File No: CHE/17/00769/FUL
Plot No: 2/1339

ADDENDUM / UPDATE REPORT

DEMOLITION OF EXISTING BUILDING AND ERECTION OF EXTRA CARE ACCOMMODATION FOR OLDER PEOPLE, LANDSCAPING AND CAR PARKING (REVISED PLANS RECEIVED 10TH, 16TH, 22ND AND 25TH JAN '2018; AND 14TH, 19TH AND 20TH MARCH '2018) AT SITE OF FORMER NORTH EAST DERBYSHIRE DISTRICT COUNCIL OFFICES, SALTERGATE, CHESTERFIELD, DERBYSHIRE, S40 9TA FOR YOUR LIFE MANAGEMENT SERVICES LTD

Proposed Site Layout (Rev C)

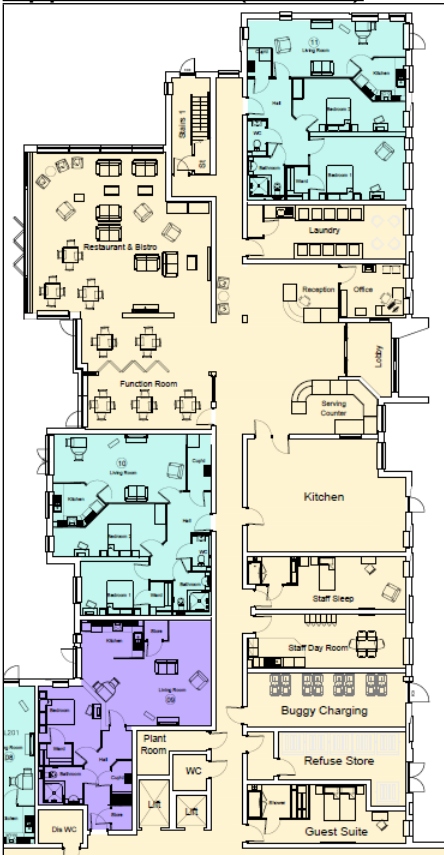
3.3 The site layout changes amend the layout of the access road to be taken off Saltergate to provide a formed access into the adjacent future development site; as well as reconfiguring the car parking layout serving the development. 34 no. car parking spaces are retained despite the reconfiguration and this is acceptable.

One inappropriate alteration relates to the layout of the entrance road and the introduction of 3 parking spaces at the end of the driveway/road. It is unclear whether these spaces are intended to serve the proposed care facility or the adjacent site identified for

These parking bays result in the terminating vista at the end of the proposed new street being defined by the presence of parked cars, which is generally poor practice. Furthermore the first parking bay (on the left as viewed from Saltergate) would require vehicles entering or leaving the space to overrun the pedestrian footpath. This represents a conflict with pedestrian and buggy movements at the nearby pedestrian access gate. In light of the above comments, it is recommended that:

- 1. The first parking bay is omitted from the end of the access road and replaced by landscaping.*
- 2. That a suitable hard surfaced path is provided along the outside edges of each remaining parking bay to prevent any adjacent soft planting from being trampled. This will enable users to enter and leave parked cars without the need to walk on planted areas, which is both impractical and results in damage to landscaped areas designed to enhance the amenity of the scheme.*

- 3. A landscape margin should be introduced between the end of the parking spaces and the boundary wall with taller shrubs planted to provide a more appealing terminating vista at the end of the new street/access road, that can be seen above any parked cars. This could be achieved by reducing the footway around the turning head to a simple/narrow service margin to free up a strip of land that could be used for soft planting.*

The entrance into the building itself and the car park arrangement are less well resolved than previously proposed and the more formal entrance threshold/space is somewhat diminished, although this in itself is not considered sufficient grounds on which to raise an objection.

3.6 Having regard to the comments of the UDO above, the applicant has been provided with a copy of the comments made above and the issues in respect of the three car parking spaces located at the end of the access road currently remain unresolved. It is however considered that this matter can be resolved by ongoing negotiation (whilst the S106 is resolved – delegated to officers) and by suitably worded condition if the S106 is signed without resolution (it is noted the access road and three parking spaces are being influenced by the adjacent landowner – rather than the developer of this scheme).

Proposed West Elevation (Rev F)

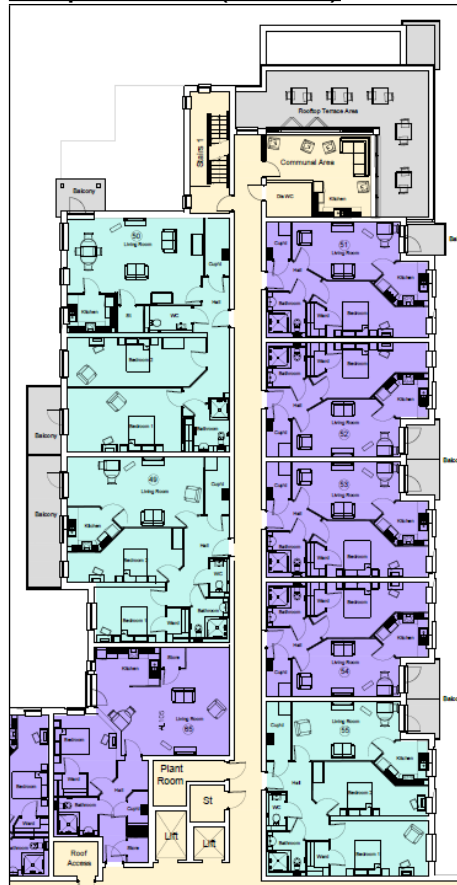
3.2 The alterations to the scheme do not materially affect the principle elevation of the development (Saltergate frontage), and the modest changes to the reconfigured layout have minimal impact upon the

appearance of the east and west elevations. The impacts of the development upon the closest neighbours which have already been closely considered retain the same relationship as previously agreed and are considered to be acceptable.
